DUNE-SP

Technical Integration

April 2nd, 2020

Top/Bottom FC Mechanical Interface

EDMS 2088738, 8760307, SHEET 3

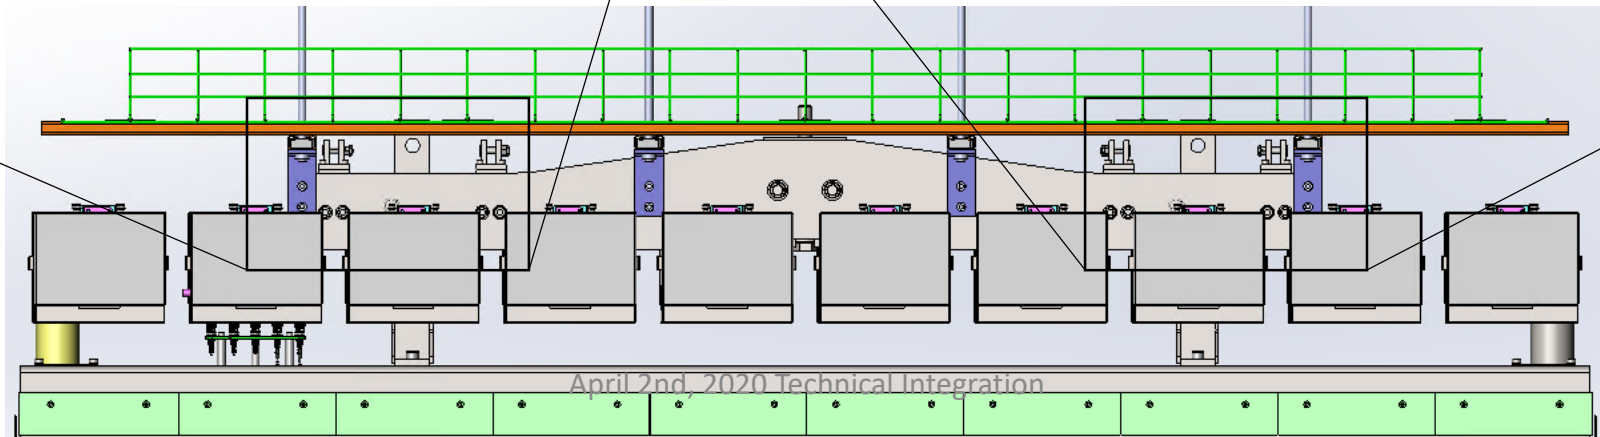
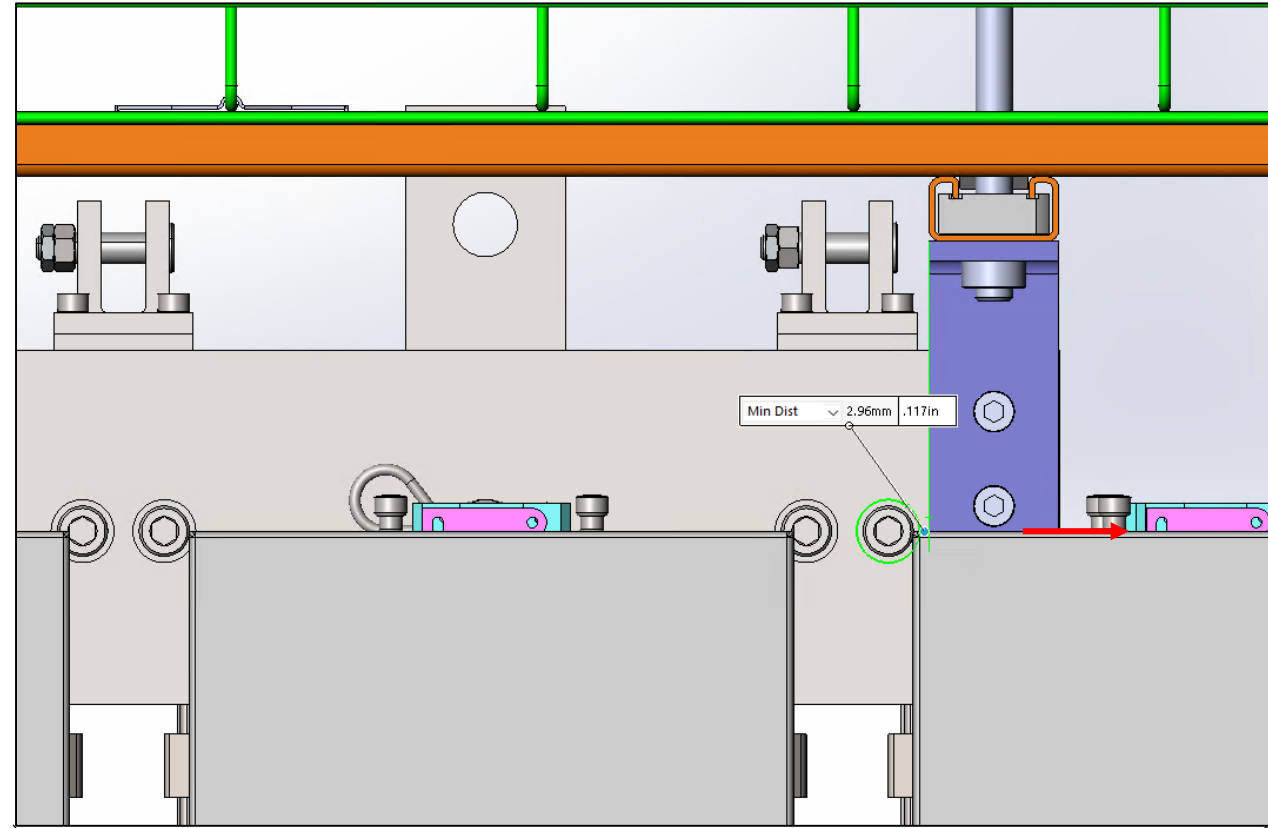
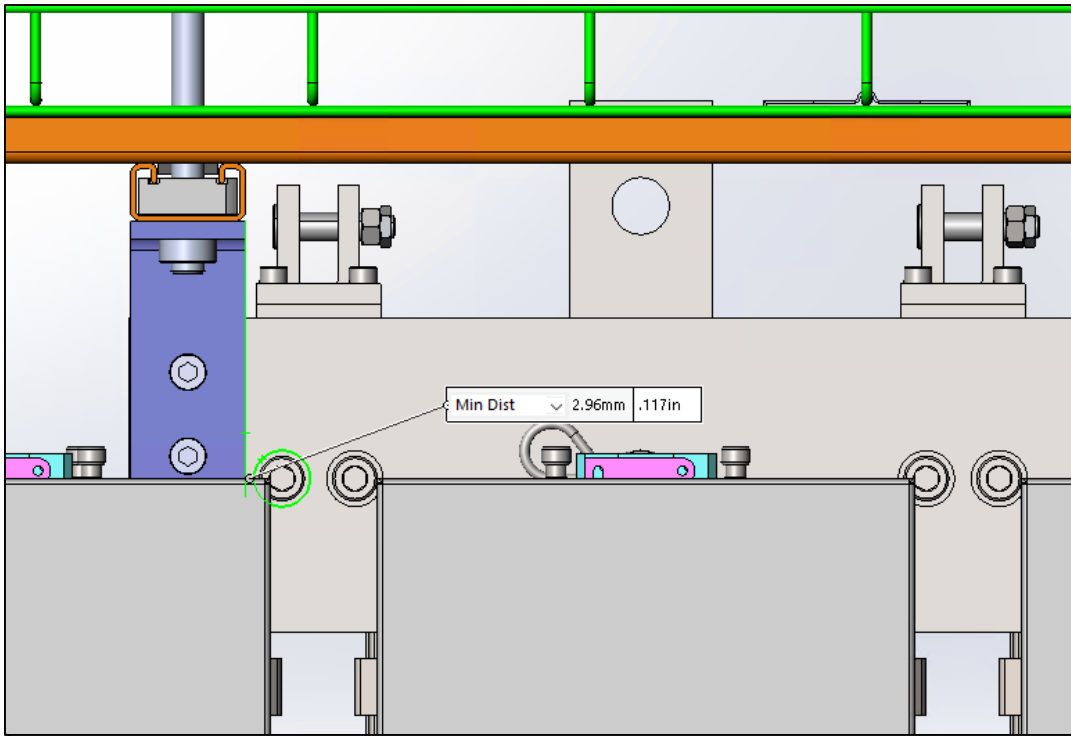
- It recently came to my attention that a change to the APA and HVS mechanical interface, at the top and bottom field cage, was proposed.
- Are there implications elsewhere?
- In the following slides, I've marked up drawings to demonstrate my understanding of what is being proposed.
- **To be taken offline**

EDMS 2088736, 8760300, SHEET 1

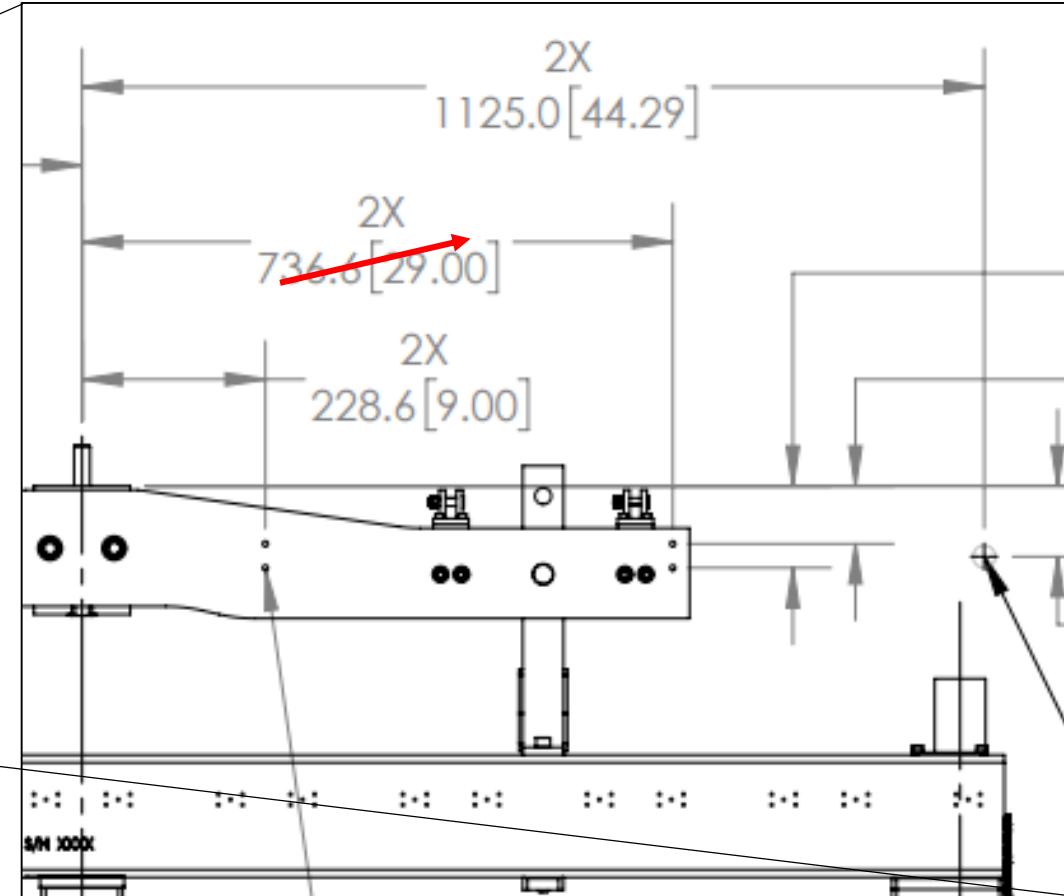
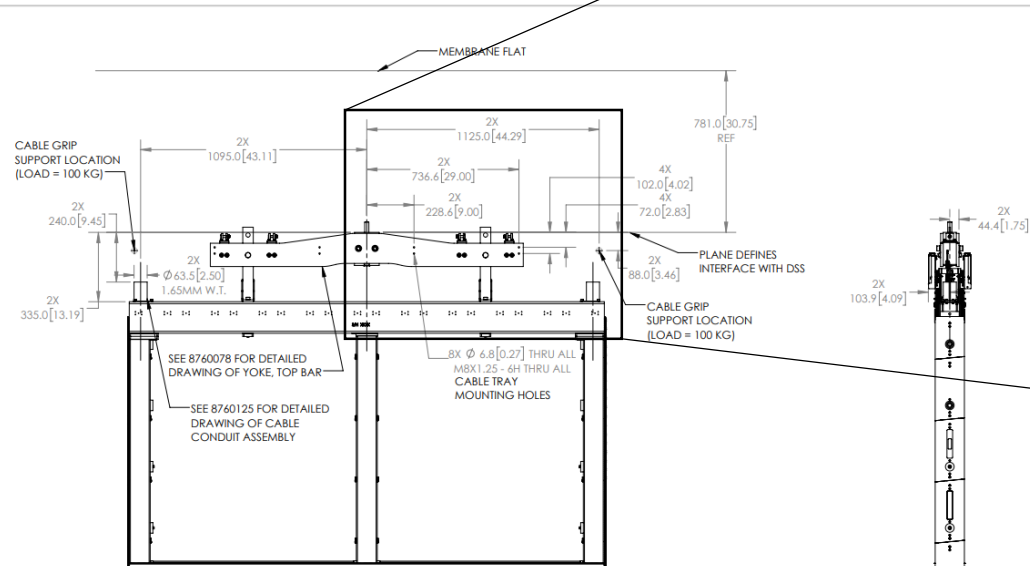
- The model shows 10.1mm of minimum clearance to a CE box
- After moving the pivots this will shrink by 7mm
